STERLING RANCH ROAD CROSSING

GRADING AND EROSION CONTROL PLAN

MAY 2022

CCES Responses

EROSION CONTROL NOTES / DETAILS

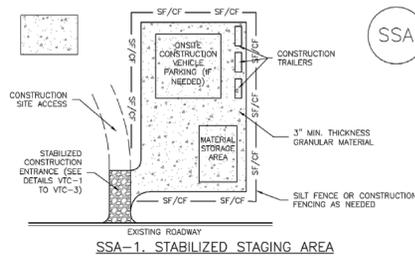
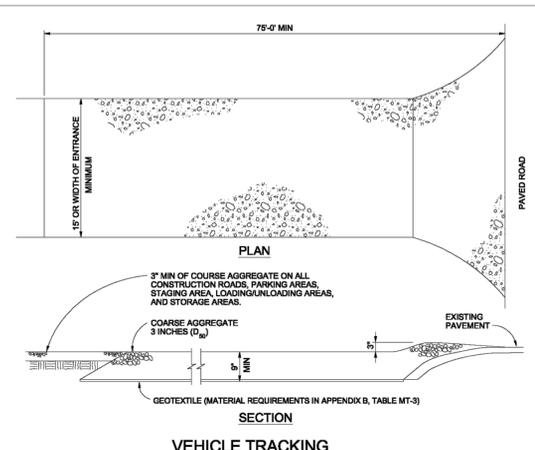
Item Z. Include details for the following BMP's. Examples of acceptable details for each are provided:

Added details on sheet 3

STERLING RANCH ROAD CROSSING GRADING AND EROSION CONTROL PLAN GEC PLAN			
DESIGNED BY	MAW	SCALE	DATE 05-01-22
DRAWN BY	MAW	(H) 1" = 50'	SHEET 3 OF 3
CHECKED BY		(V) 1" = N/A	JOB NO. 1183.11

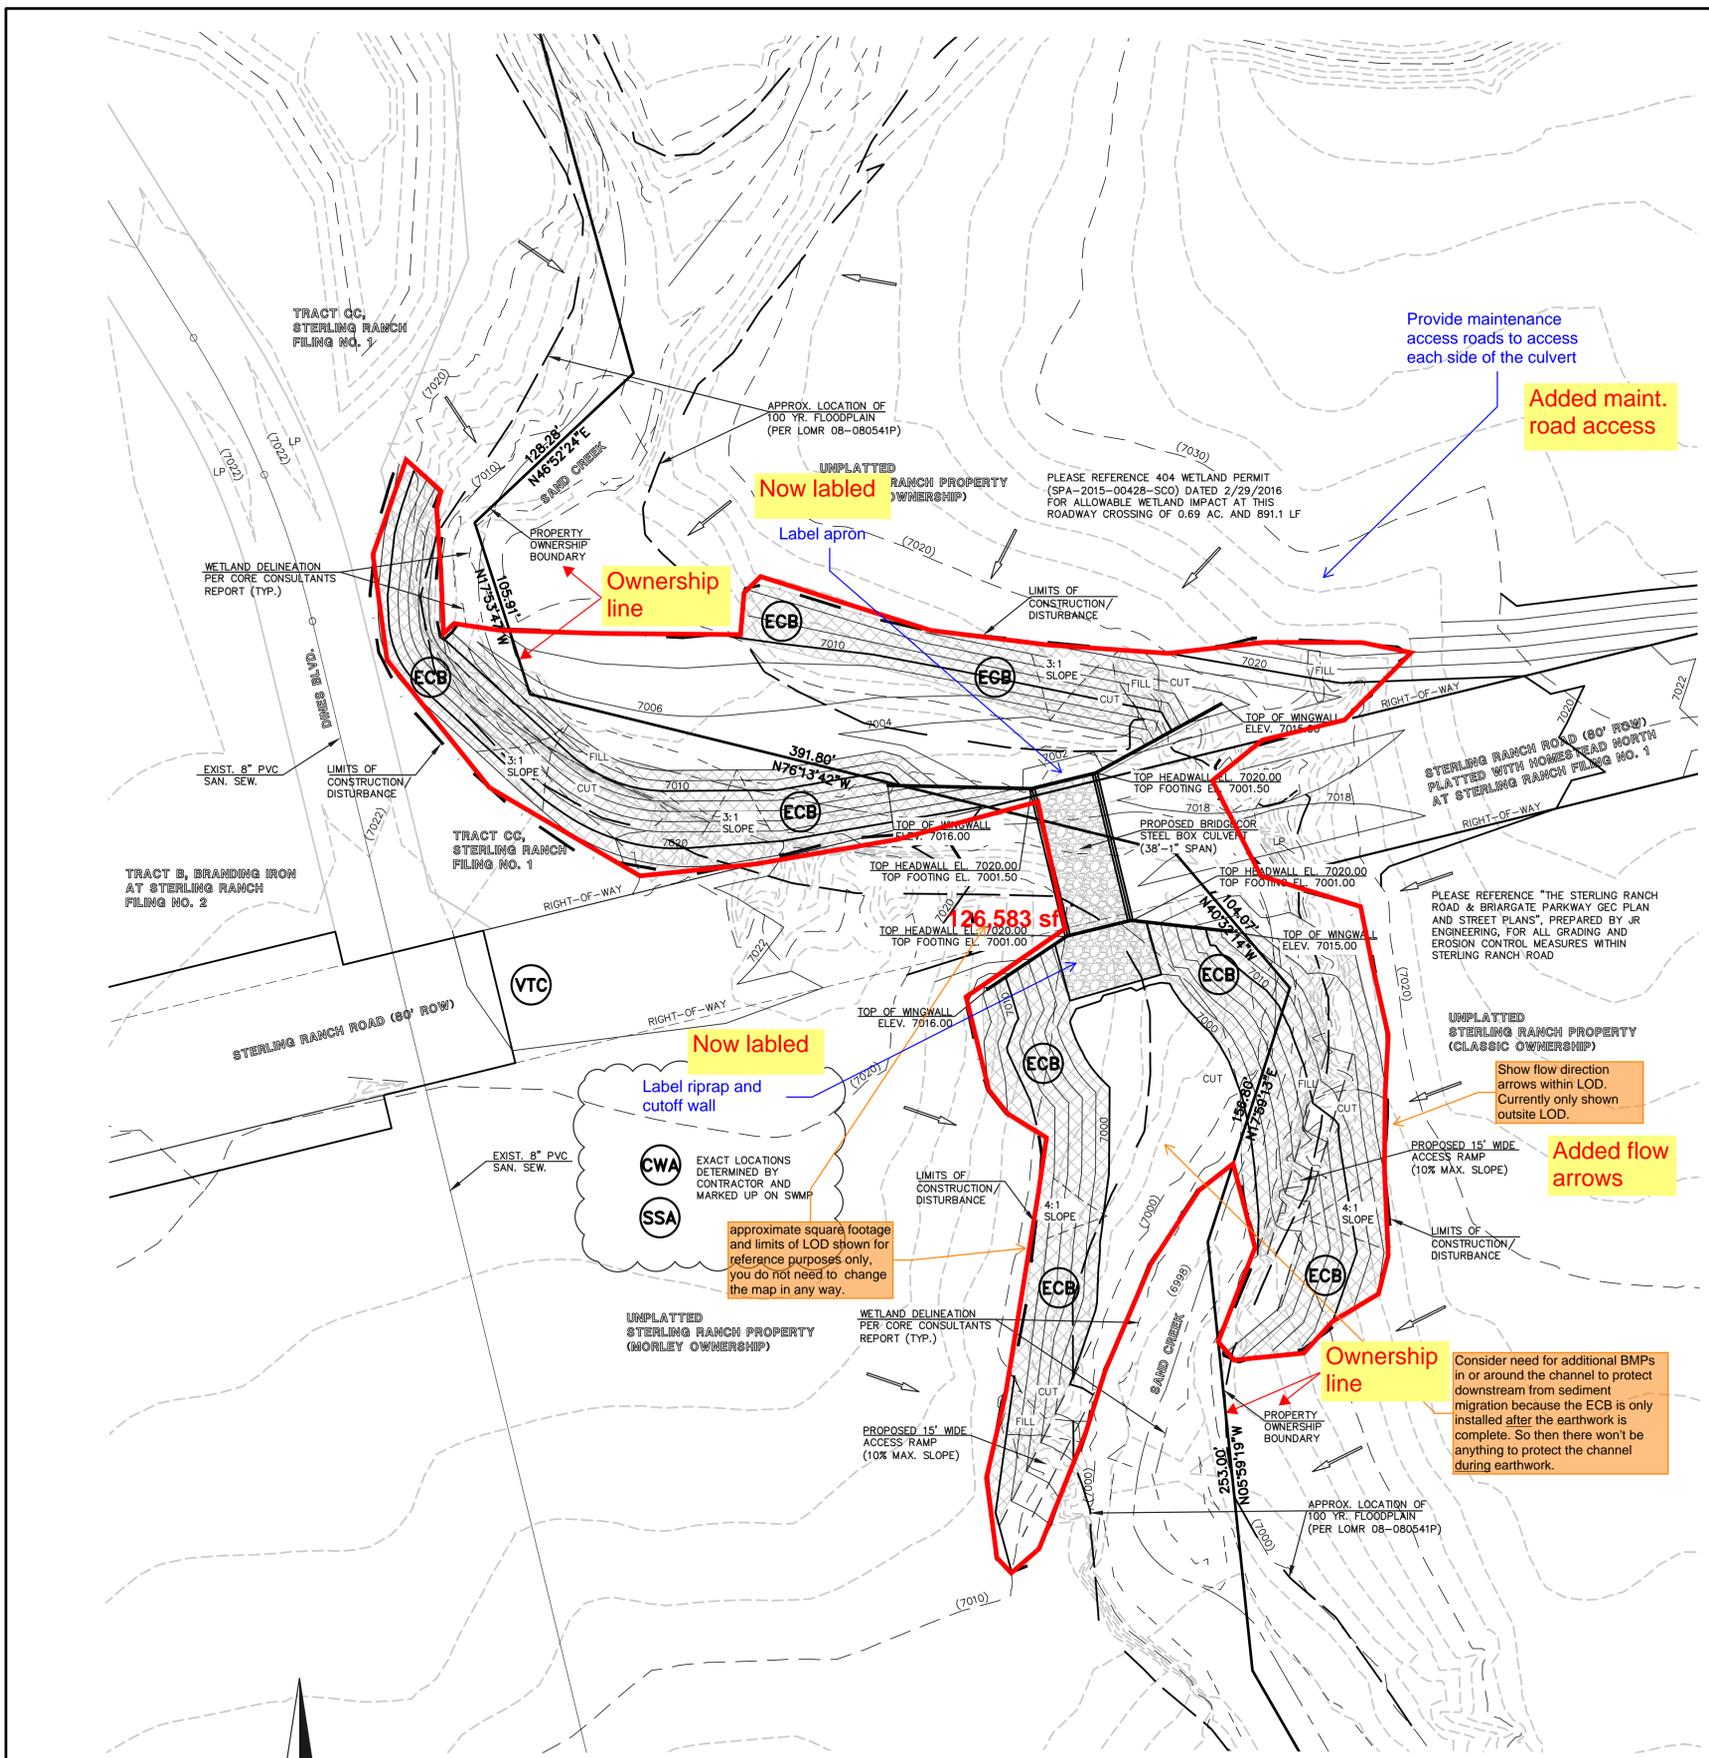
Checklist item "e" - show property lines, especially the line between Morley and Classic discussed in the LOI.

Now labeled
Label apron

Now labeled
Label riprap and cutoff wall

It may be difficult to see but the property ownership line is currently shown and labeled. See below

Ownership line

Added maint.
road access

Added flow
arrows

Ownership line
